Our Ref: PTF-JBA-XX-XX-LT-Z-0001-S0-P01.01-
Response_to_Planning_Concerns.docx

Response to Planning Comments for Planning Application 25/0497

Figure 1 - Location of flood defences

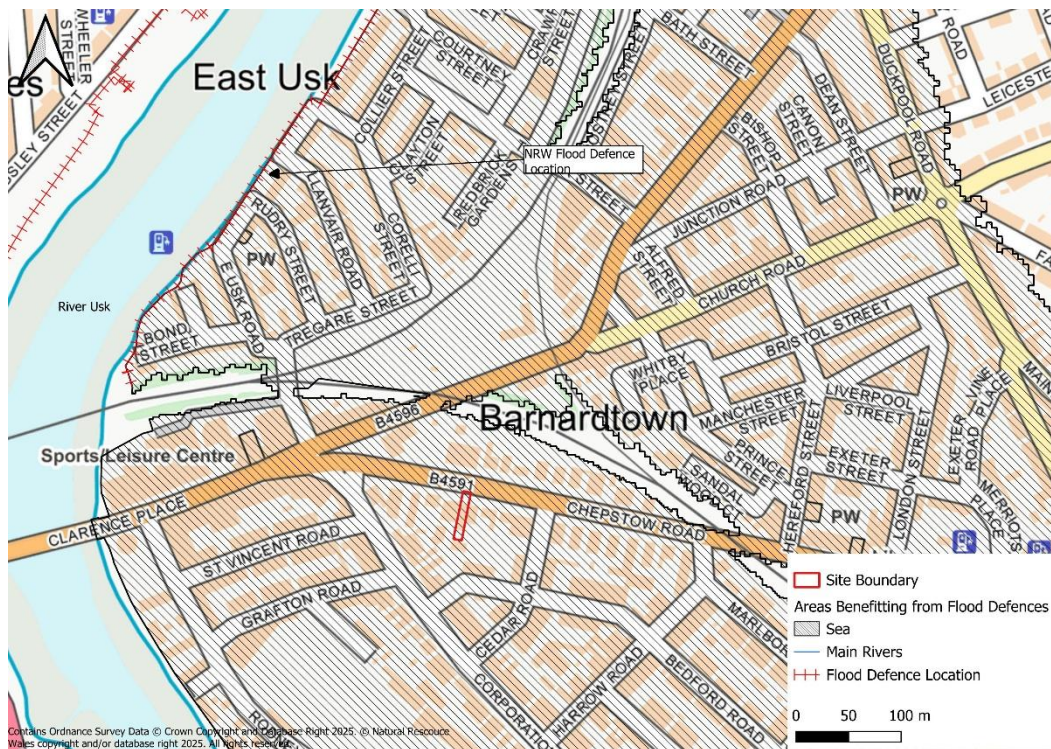
4. NRW state that TAN15 requires overtopping and breach assessment. However, TAN15 6.8 only requires this 'where appropriate'. We can confirm that the flood modelling includes for the overtopping of flood defences. Furthermore, we have considered carefully the requirement for breach modelling at this location. Figure 1, below, shows the location of the closest and most relevant flood defence to the site, approximately 350m northwest of the site.

Given scale, nature and modern design of the flood defence, it is difficult to conceive of a realistic failure mechanism with anything other than the remotest probability of occurrence. We have therefore concluded that it would not be appropriate or proportionate to undertake breach modelling.

Notwithstanding this, the predicted flood level in the extreme 0.1% AEP design event, without breach, only differs by ~200mm between the river and 22 Chepstow Road. Therefore, a breach in the flood defence would not significantly change the flood risk at the site in the extreme event.

Figure 2 Riverside FAS - typical section (approved plans)

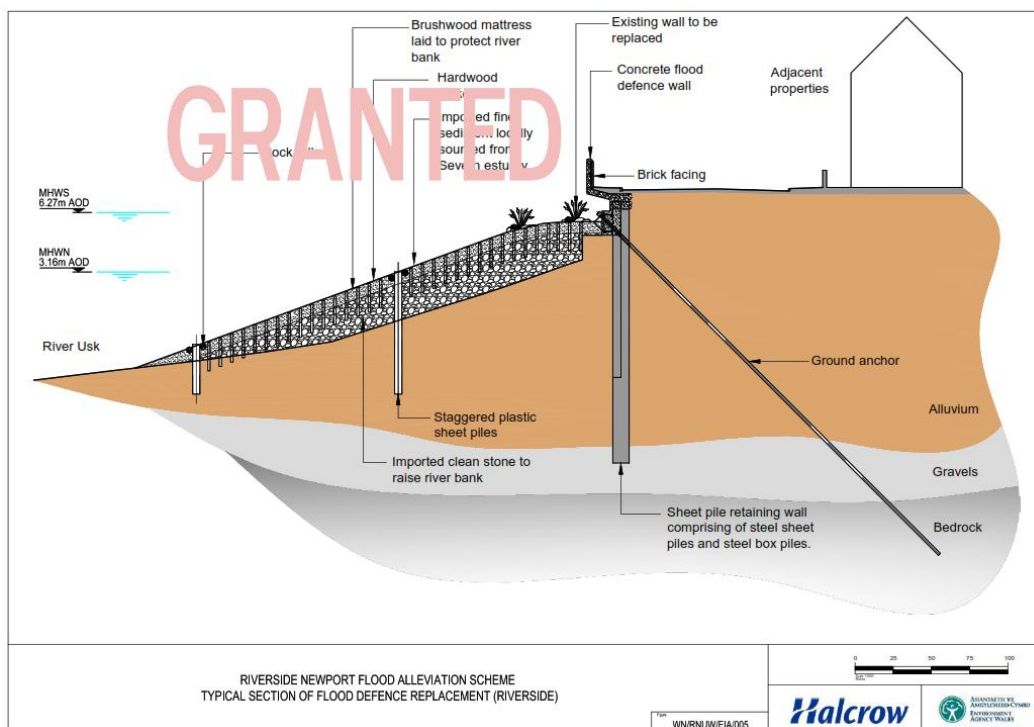
This flood defence consists of NRW's Riverside Flood Alleviation Scheme (FAS). The £7m Riverside FAS was completed by NRW in 2012 (planning ref. 10/1322). It consists of very large sheet piles and ground anchors, driven to a significant depth into the banks of the River Usk. The flood defences were designed to accommodate the additional loading of being further raised in the future to account for climate change. The design of the defence is shown in Figure 2, below.
